Economic Commission for Europe**Inland Transport Committee****World Forum for Harmonization of Vehicle Regulations****Working Party on Lighting and Light-Signalling****Seventy-eighth session**

Simplification of lighting and light-signalling Regulations**Proposal for Supplement [11] to the 06 series of amendments to Regulation No. 48 (Installation of lighting and light-signalling devices)****Submitted by the Informal Working Group on Simplification of Lighting and Light-Signalling Regulations (IWG SLR)***

Example 8

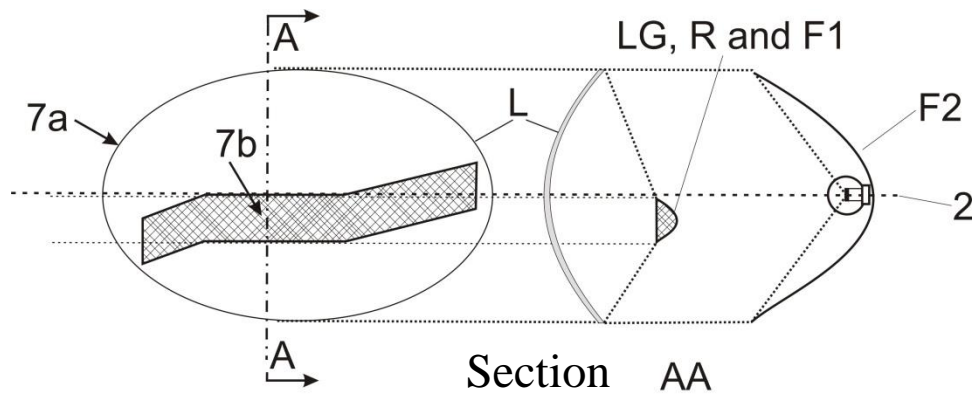
In the case where the non-textured outer lens is excluded, "7b" is the apparent surface according to paragraph 2.8-2.10.2. (b).

In the case where the non textured outer lens is excluded, "7b" is the apparent surface according to paragraph 2.8- 2.10.2. (b), and F1 shall not transparent to F2

Example 9

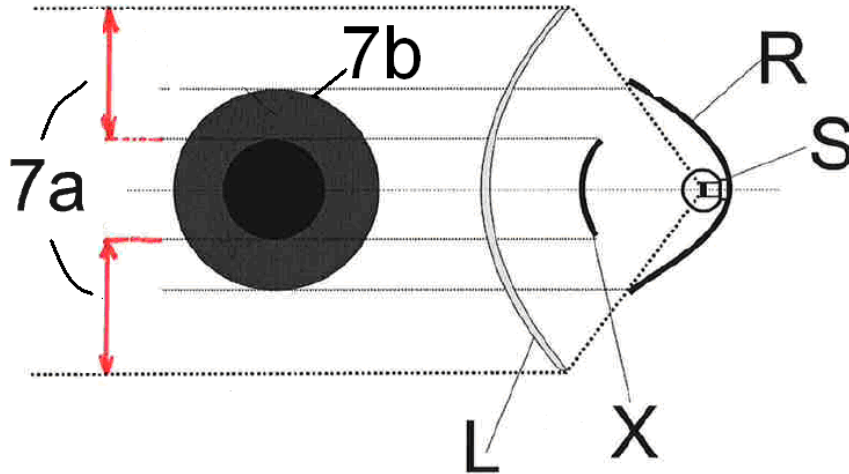
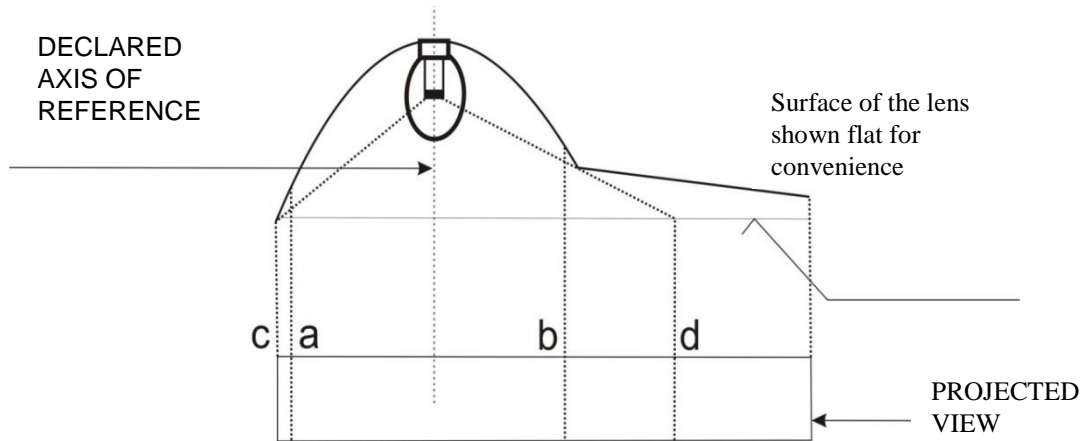
In the case where the non textured outer lens is excluded, "7b" is the apparent surface according to paragraph ~~2.8.~~ 2.10.2. (b).

Example A

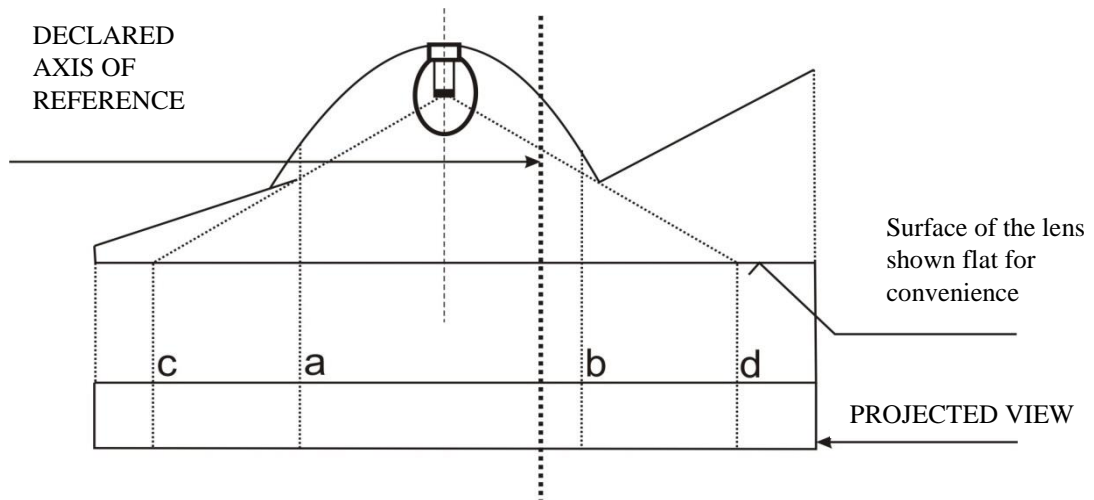
<i>Illuminating surface</i>	<i>Declared light-emitting surface according to 2.8. 2.10.2. (a)</i>
Edges are	a and b	c and d

Example D

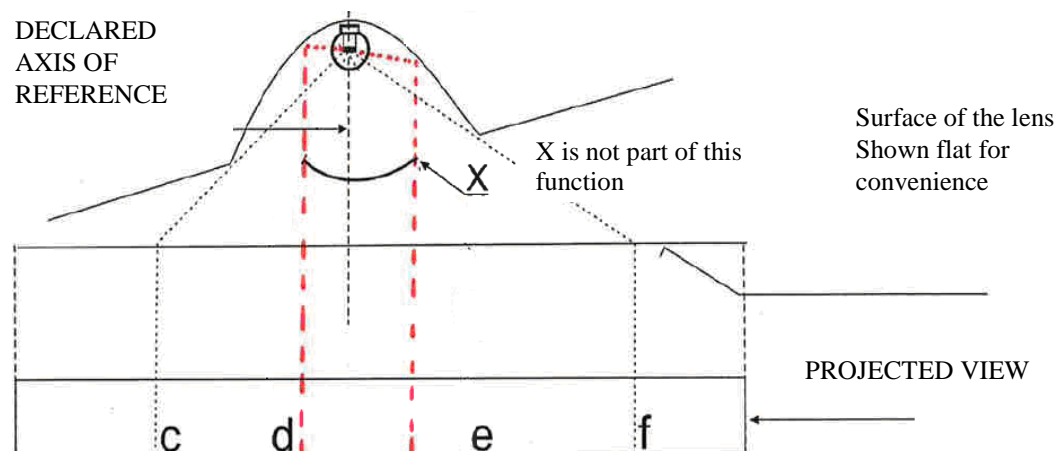
Example to determine a light emitting surface according to 2.8-2.10.2. (a) in combination with an area which is not part of the function:

<i>Declared Light-emitting surface according to 2.8-2.10.2. (a)</i>
Edges are	c-d and e-f

Example E

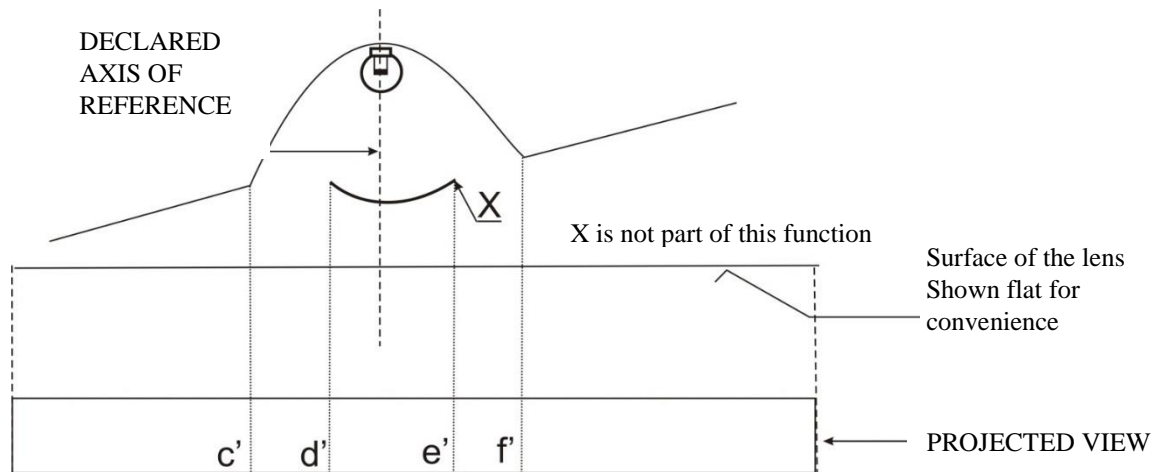
Example to determine the apparent surface in combination with an area which is not part of the function and a non-textured outer lens (according to 2.8-2.10.2. (b)):

<i>Declared Light emitting surface according to 2.8-2.10.2. (b) for example</i>
Edges are	c'-d' and e'-f'

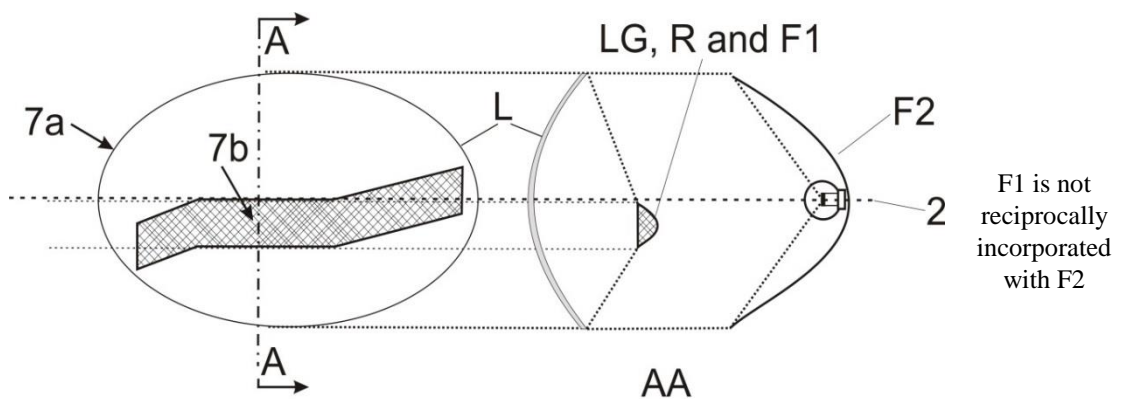
In the case where the non-textured outer lens is excluded, "7b" is the apparent surface according to paragraph 2.8-2.10.2. and F1 shall not be transparent to F2:
